Access Compliance Report

Public Rights-of-Way

(Curb Ramps)

Intersection ID: 42752	Main Street: ASHLEY_MEADOW_DR	Cross Street: SAWMILL_TRACE_DR	Location: E
ADA ID: 0C742151B9CE	Ramp Type: PerpDiag	Initial Pass/Fail: Fail	Overall Compliance: No
Severity Score: 12.5			
Codes/Mitigation Info/Possible Solution		Field Measurements/Component Compliance

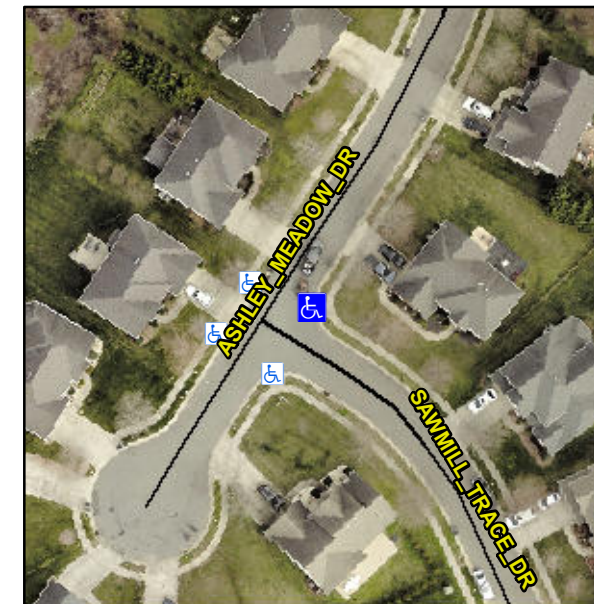
Not Found, R304.2.2

Compliance	Description	Data	Compliance	Description	Data
N/A	Ramp Length (in)	51.0	No	Ramp Slope (%)	10.6
Yes	Ramp Width (in)	48.0	Yes	Ramp XSlope (%)	0.4
N/A	Flare Type LT	N/A	N/A	Flare Type RT	N/A
N/A	Flare Slope LT (%)	N/A	N/A	Flare Slope RT (%)	N/A
N/A	Flare Traversable LT?	N/A	N/A	Flare Traversable RT?	N/A
N/A	Landing Length (in)	N/A	N/A	DWS Provided?	N/A
N/A	Landing Width (in)	N/A	N/A	DWS Contrast?	N/A
N/A	Landing Slope (%)	N/A	N/A	DWS Length (in)	N/A
N/A	Landing X Slope (%)	N/A	N/A	DWS Full Width?	N/A
N/A	Landing Curb? (Y/N)	N/A	N/A	DWS Offset (in)	N/A
N/A	Shared Landing?	N/A			
N/A	Gutter Ponding?	N/A	N/A	Gutter Slope (%)	N/A
N/A	Gutter Lip Ht (in)	N/A	N/A	Gutter X Slope (%)	N/A
N/A	Painted X Walk1?	No	N/A	Painted X Walk2?	No
	X Walk 1 Direction	To NW		X Walk 2 Direction	To SW
N/A	X Walk 1 Width (in)	N/A	N/A	X Walk 2 Width (in)	N/A
	X Walk 1 Slope (%)	0.4		X Walk 2 Slope (%)	0.4
	X Walk 1 X Slope (%)	0.7		X Walk 2 X Slope (%)	1.9

Remove & Replace Curb Ramp With Two New Directional Ramps or Equivalent.
